CR221 – Check and Possible Re-Route of Instrument Panel Wiring

Monster (937cc) MY 21-22 (all versions)
Technical Service Bulletin SRV-TSB-21-009

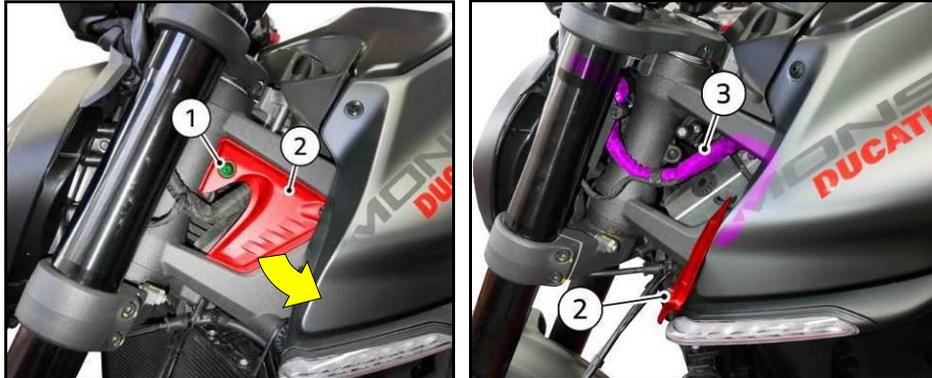
1. Working on vehicle LH side: Remove screw with collar M5x9 (1) retaining the RH cover (2) to check the routing of headlight branch (3).

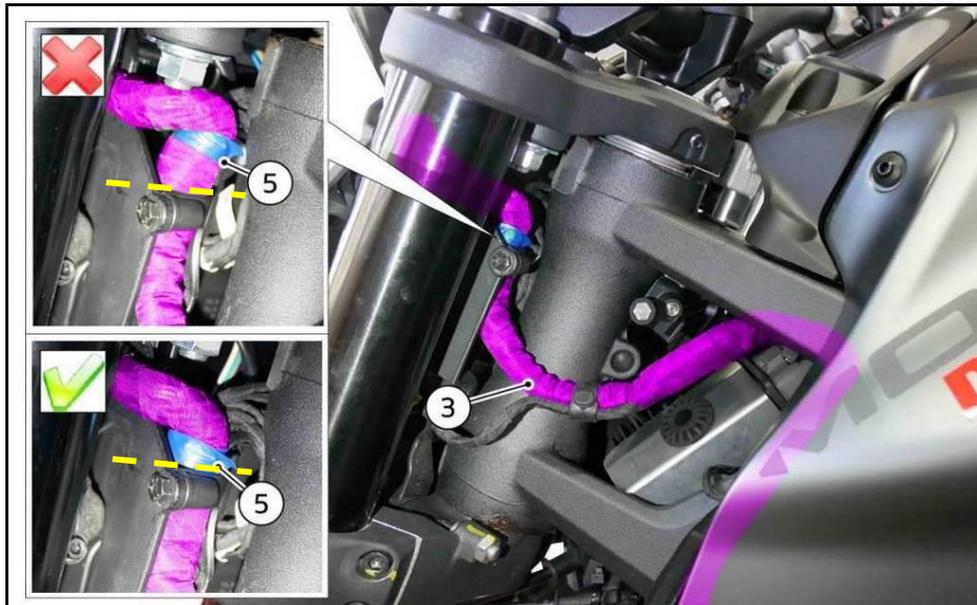
2. The blue taping (5) present on instrument panel wiring (3) must be positioned on the front wiring guide, as shown in the figure (taping must slightly protrude over the special guide).

- If the taping IS in the correct position, reinstall the LH cover by tightening the 2 screws with collar M5x9 to 3 Nm ± 10%
- If the taping IS NOT in the correct position, proceed to Part 2 **Instrument Panel Harness Re-routing**

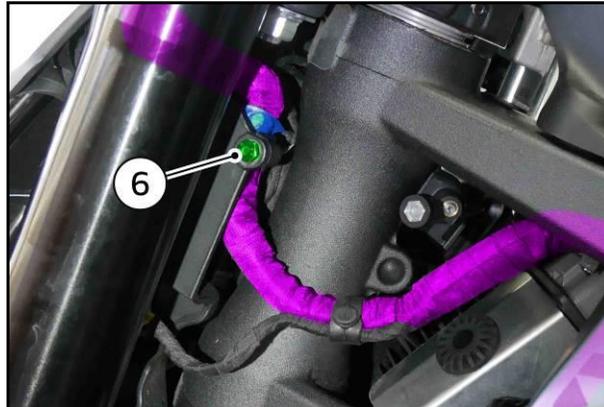
1. Loosen screw (6) retaining the front wiring guide and correctly re-route wiring, as shown in the figure.

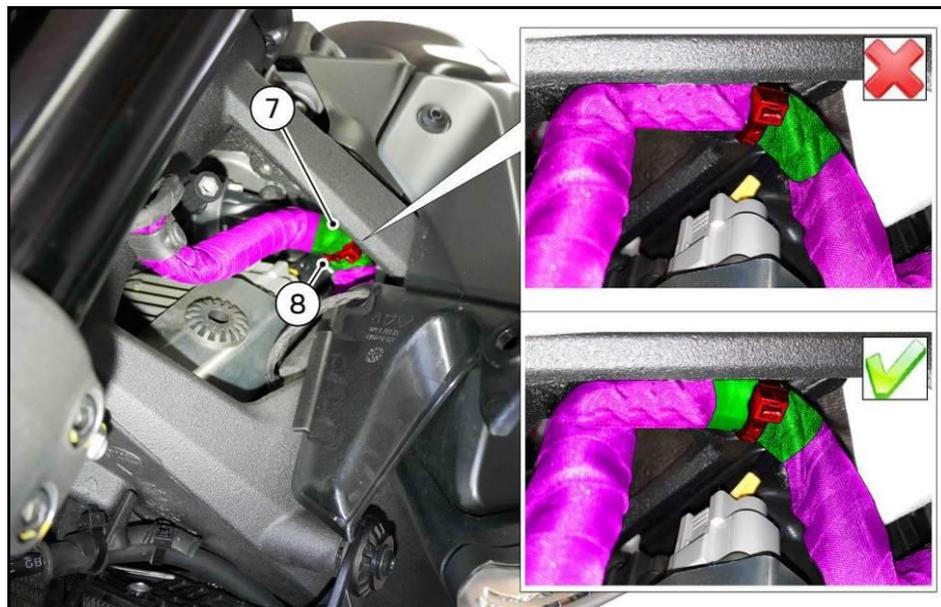
2. The black heat-shrink sheath (7) (highlighted in green in the figure) must be positioned at the center of the large self-locking tie (8), as shown in the figure. (NEVER to the right or left of tie).

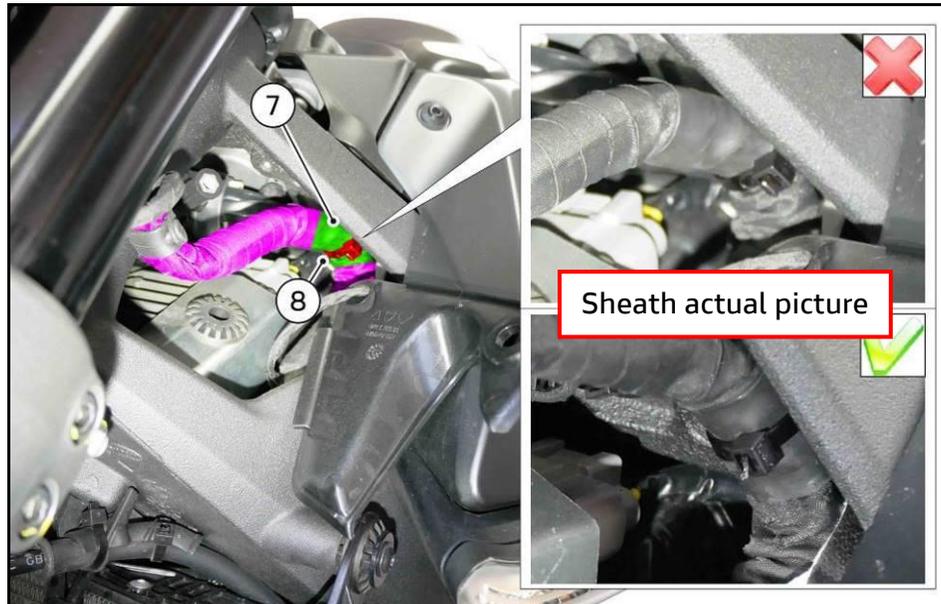
2 A. Should the tie be already correctly positioned at the center of the sheath, mark the check with a felt pen (see figure below), then proceed to step 8

2 B. Should tie not be positioned as specified above, re-position it by following the procedure from step 3 forward

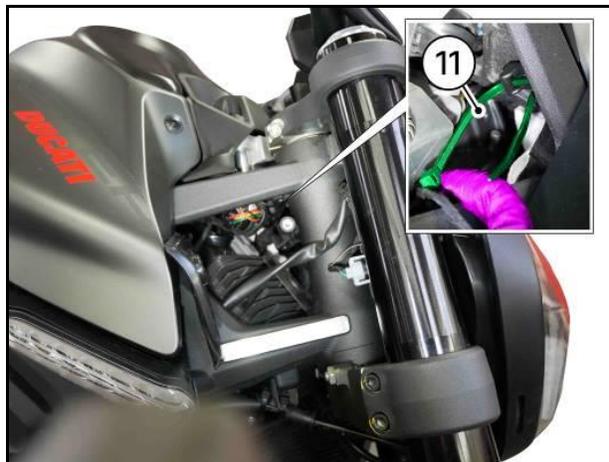
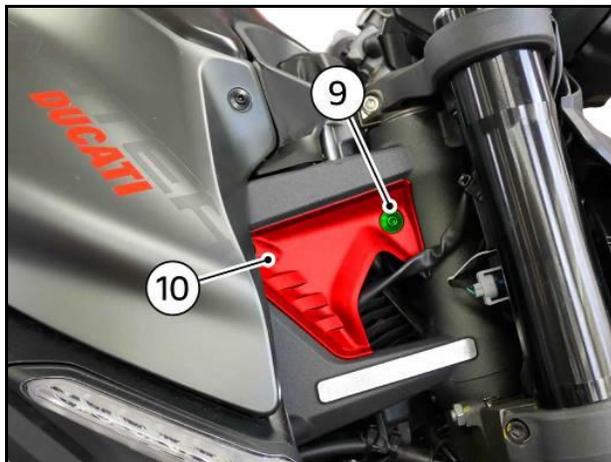
3. Remove the self-locking tie
4. Use a felt pen to make a mark on sheath centerline

5. Insert the new large self-locking tie (11) inside the seat on frame, aiming it as shown in the figure

For easier fitting of the self-locking tie into its housing, work from the right side of the vehicle, by removing the screw with collar M5x9 (9) retaining the cover (10).

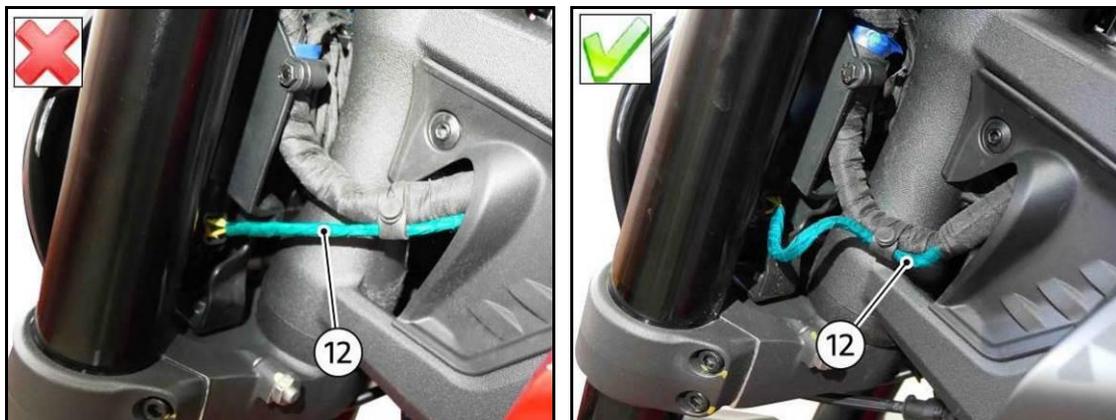
6. Re-route instrument panel wiring with the marking just made on the sheath at the center of tie

7. Tighten tie to fasten wiring in its position
8. Re-position RH and LH covers by tightening the 2 screws with collar M5x9 to **3 Nm± 10%**.

During re-routing, make sure that **headlight wiring branch (12)** has adequate slack for movement.
